Service Bulletin	SB AD32/08 Revision: 1.0
---	---------------------------	--

TITLE:	Hardware Modification for AD32 Air Data Display (Antivibration measure for AD32 HW4.10)
DOCUMENT NUMBER:	SB AD32/08
EQUIPMENT:	AD32 Air Data Display
© Copyright by THOMMEN AIRCRAFT EQUIPMENT AG, CH-4132 Muttensz, Switzerland

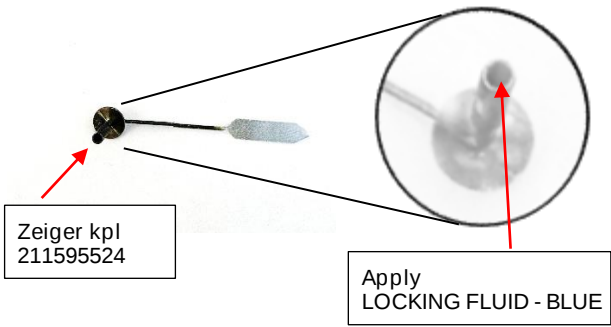
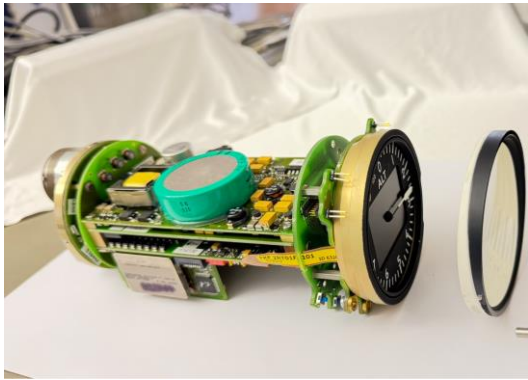
STEP	PICTURE	PROCEDURE
2	 Zeiger kpl 211595524	Dismantle the front ring and housing. Gently remove the pointer (Zeiger kpl) from the fitting of the motor kpl. <i>This procedure and steps 3 to 4 only need to be carried out if the pointer is not already glued to the motor shaft.</i>
3	 Zeiger kpl 211595524 Apply LOCKING FLUID - BLUE	Apply LOCKING FLUID - BLUE in the shaft of the pointer with a SYRINGE. Make sure that a small amount is sufficient. The Locking fluid should not overflow from the socket. Without any further delay stick the pointer back into the motor shaft.
4		Put all parts back in place. Press the centering ring on the main assembly. Make sure that the recess at the bottom of the centering ring aligns with the recess next to the lighting PCB.

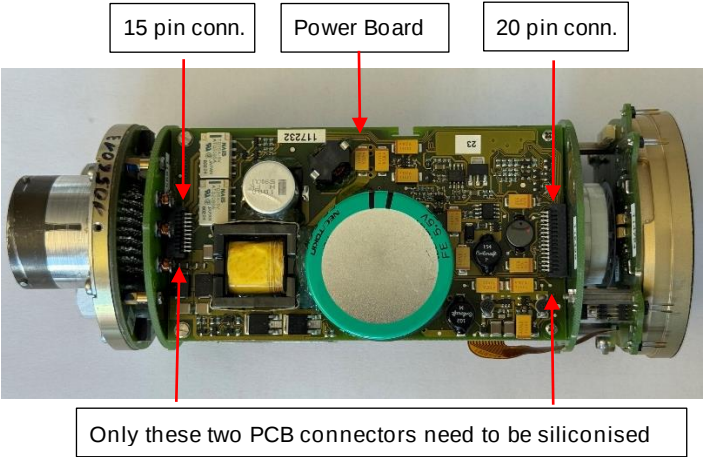
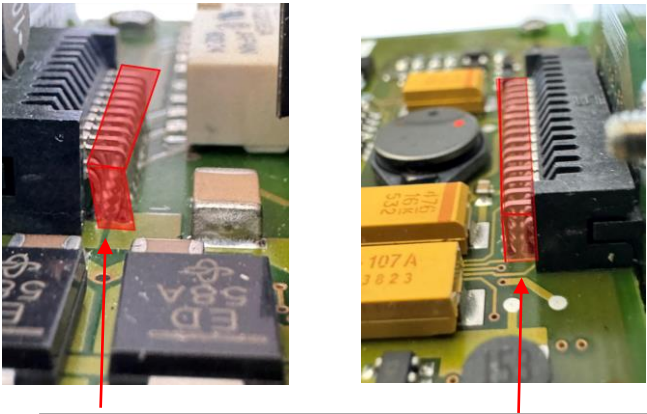
STEP	PICTURE	PROCEDURE
5	 15 pin conn. Power Board 20 pin conn. Only these two PCB connectors need to be siliconised	Prepare the siliconization of the PCB connectors on the Power board. This treatment is done only for the two connectors on Power board. Apply SILICONE ADHESIVE on the angled 20 pin and the 15 pin PCB connector. <i>This procedure and step 6 must be carried out if SILICONE ADHESIVE has not already been applied to the PCB connectors.</i>
6	 Cover only the pins with SILICONE ADHESIVE	Only cover the pins with the SILICONE ADHESIVE . No SILICONE ADHESIVE should get between two PCBs. The power board must still be removable after this treatment.

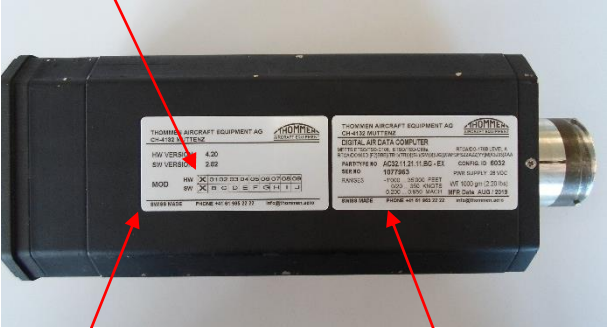
STEP	PICTURE	PROCEDURE
7	HW MOD status  MOD status label Identification label	Assemble all parts together. Print a new MOD status label with the HW MOD status incremented (all other information is unchanged). Print a new identification label (all information is unchanged). Attach the new labels to the new housing as shown in the photograph. NOTE: The photograph shows only typical identification labels. Do not copy the information shown.
